Certificate of Appropriateness

Property 2015 N. PALMER ST.

Date issued 9/12/2017 PTS ID 114358 COA: replace 2nd floor front windows

Exact design for front windows. Rear window shall be the same style with the same sash member thicknesses, but with dimensions adjusted as needed and arch-topped glass optional.

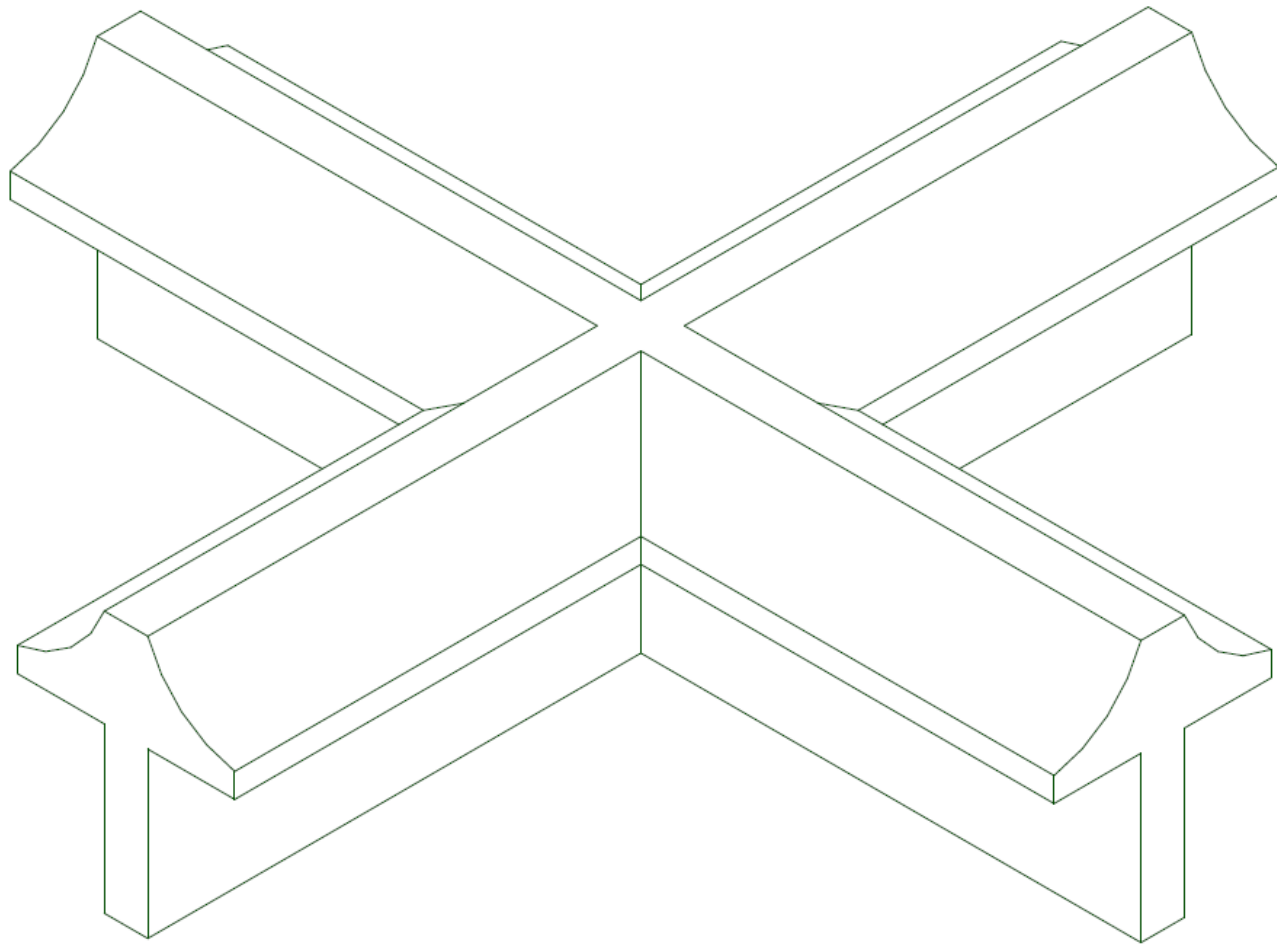
Description of work Replace all three front second story windows and one second floor rear window. All windows shall be all wood with true divided light and coved muntins in a in two-over-two configuration. Front windows shall fit the existing opening and match the arch per attached drawing with arched glass in the top sashes. Glazing in rear window may be rectangular and not does not need to conform to the segmental arch of the window opening.

1. Any new storms/screens to be all wood.
2. Any Low-E glazing must be clear and untinted.
